## ORIGINATION FORM

Proposed Revisions to a Standard Plans Index  
(Please provide all information — Incomplete forms will be returned)

Index Number: 455-054

Index Title: 54" Square Precast/Post-Tensioned Concrete  
Cylinder Pile

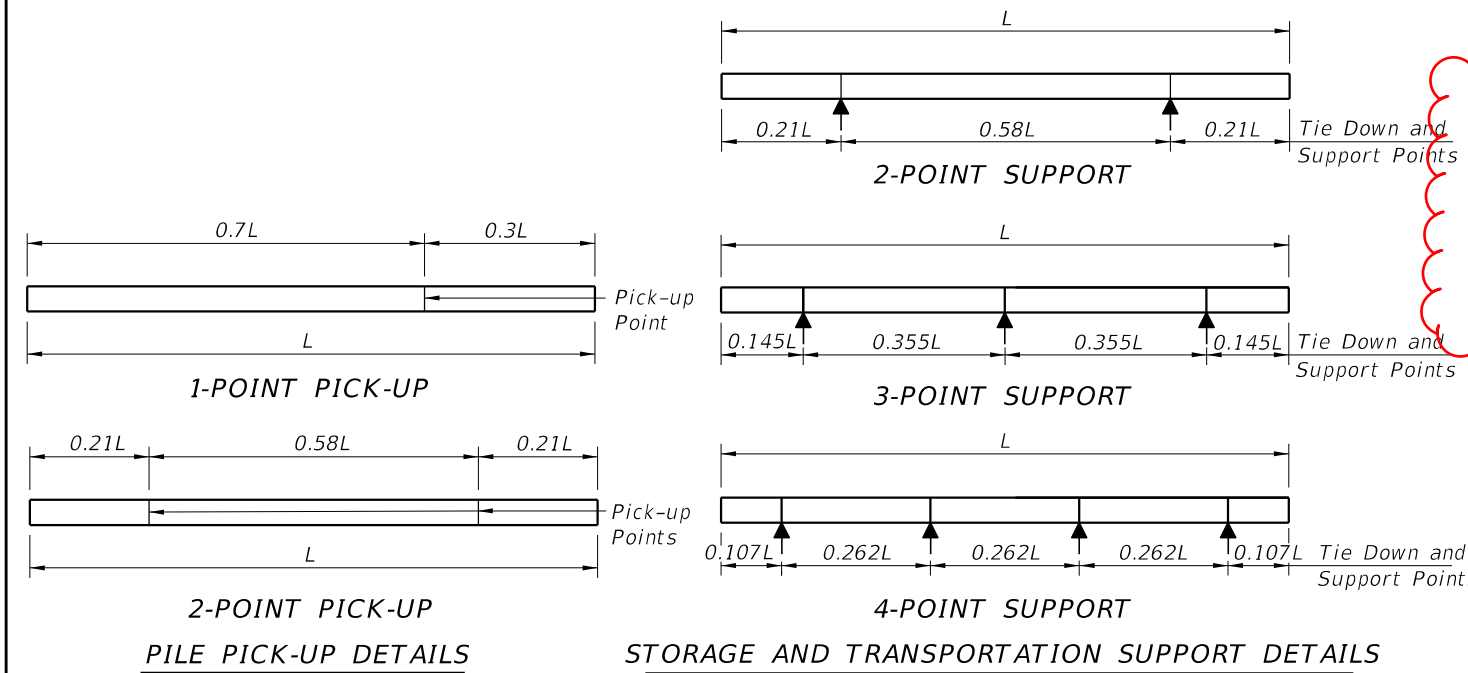
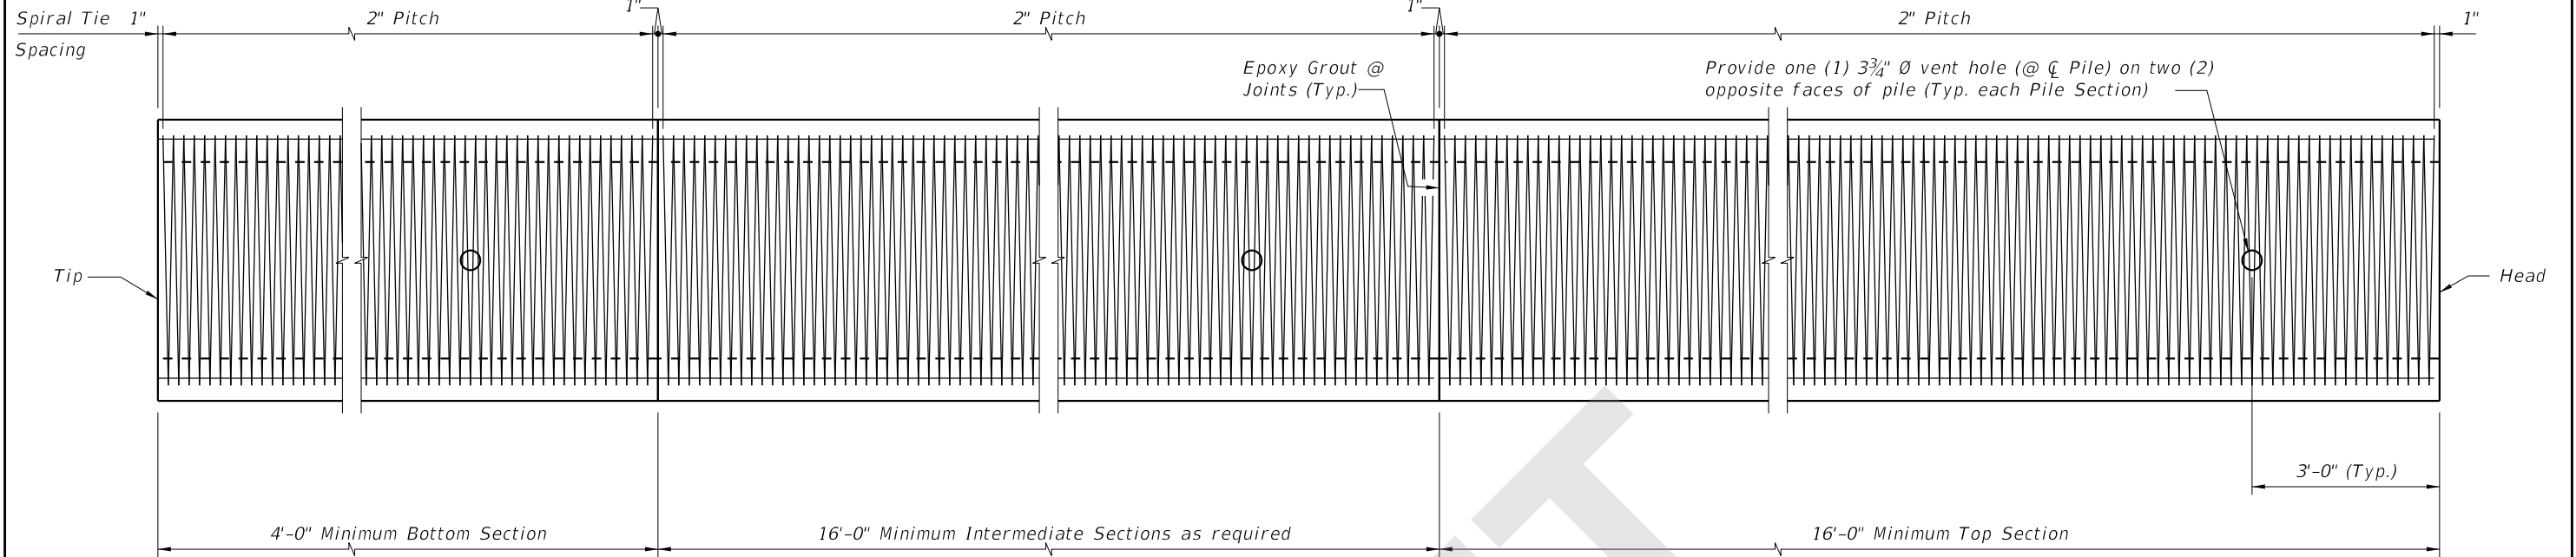
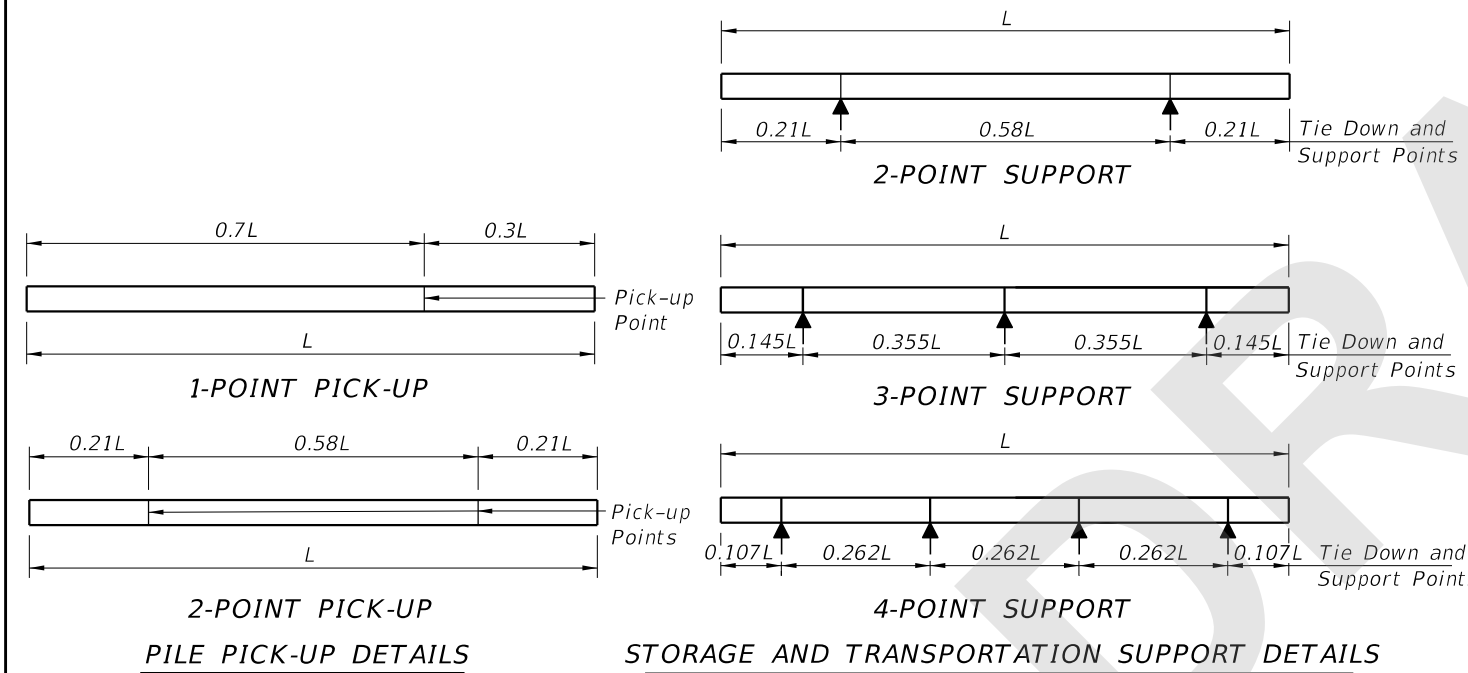
Change Silica Fume, metakaolin or ultra-fine flyash to Highly Reactive Pozzolans

Specification changed to fit silica fume, metakaolin and ultra-fine flyash under Highly Reactive Pozzolans

- Work this Index with the Pile Data Table in the Structures Plans.
- Concrete:
  - Piles: Class V (Special).
  - Splice: Class IV.
  - ~~Silica Fume~~: See "GENERAL NOTES" in Structures Plans for locations where the use of silica fume, metakaolin or ultra-fine flyash is required.

Highly Reactive Pozzolans

- Work this Index with the Pile Data Table in the Structures Plans.
- Concrete:
  - Piles: Class V (Special).
  - Splice: Class IV.
  - See "GENERAL NOTES" in Structures Plans for locations where the use of Highly Reactive Pozzolans is required.
